Attachment A Response to Request for Additional Information #1

The Applicant submitted the following responses to DPHI on 5 February 2025, with the responses subsequently referred to agencies for review and additional comment. Therefore, these matters are considered closed with the Applicant's response to following comments included at **Attachment B**.

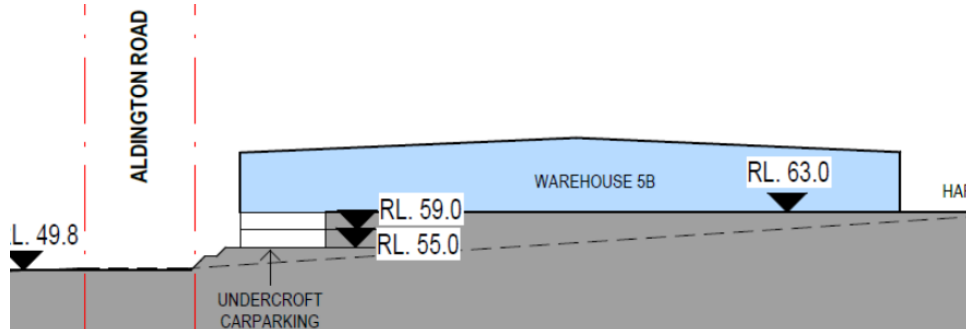
- Provide further consideration of the proposed pad levels for Lot 6, in particular Lot 6B (now separately referred to as Lot 5), and options to reduce the level differences between Aldington Road and the future built form on that lot, including further stepping or other alternatives to managing level transitions within the lot(s). Concern is raised with the current proposal for the development on this lot and resultant built form height to Aldington Road as shown in the below section:

The civil design for the Westlink Industry Park has been designed to create a balanced cut and fill balance in accordance with the MRP DCP to reduce heavy vehicle movements off-site and the need for import or export of fill from offsite. As detailed in the Submissions Report, an evidence-based and spatial decision-making framework has been used to determine the civil design (refer to **Figure 2**).

A reduction in the Lot 5 pad level will result in significant amounts of export, reducing compliance with the MRP DCP and subsequently significantly increasing heavy vehicle generation. The Applicant outlines that a reduction is not feasible from a delivery perspective.

A suitable built form can be achieved on Lot 5 through the positioning of parking and office space underneath the warehouse form. This enables the replacement of retaining walls for a more active frontage support by landscaping along the street frontage. The provision of office space would be located on the corner of the built form to reduce the bulk and scale of development and maximise views.

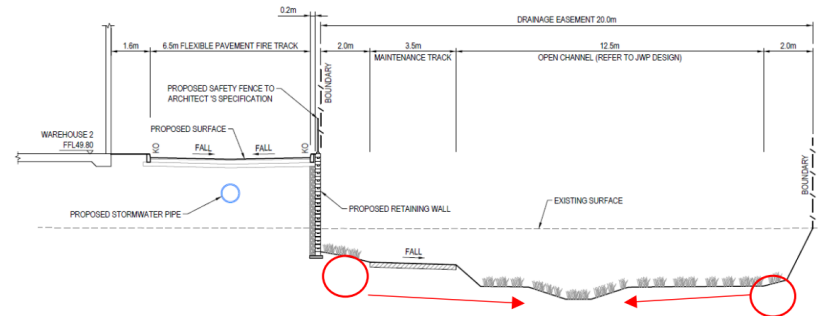
<ul style="list-style-type: none"> The current design does not achieve the target for Sinuosity. <ul style="list-style-type: none"> Sydney Water recommend increasing the average wavelength. After retaining a minimum 1m buffer, the proponent could potentially transfer the remaining portion of the 2m buffer next to the maintenance track to the upper bank to allow for an appropriate channel wavelength 	<p>JWP have collaborated with Sydney Water on the sinuosity assessment and related channel design solution. Outcomes of these meetings were agreed via email on October 2024 and 27 November 2024. These emails are included at Appendix B of the updated Trunk Drainage Design Report (Attachment K).</p> <p>The instruction provided by Sydney Water has informed the documentation of the updated trunk drainage design to meet their requirements. Refer to updated Trunk Drainage Drawings (Attachment J).</p>
